Addendum 128 – UN Regulation No. 129

Revision 1 - Amendment 9

Supplement 8 to the 01 series of amendments – Date of entry into force: 22 June 2022

Uniform provisions concerning the approval of Enhanced Child Restraint Systems used on board of motor vehicles (ECRS)

Figure 3
Minimum distance for lateral impact

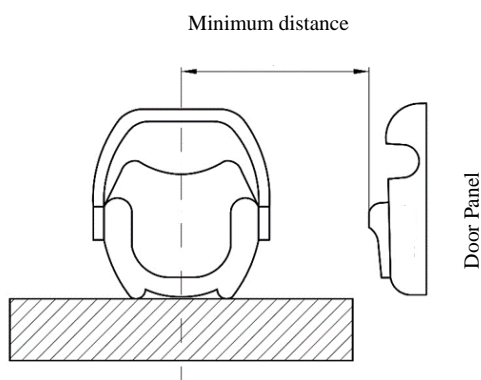
For each test, the initial position of the side impact door panel relative to the bench shall be adjusted according to the minimum distance between the vehicle's door panel and the centre of the seating position as shown in Figure 3.
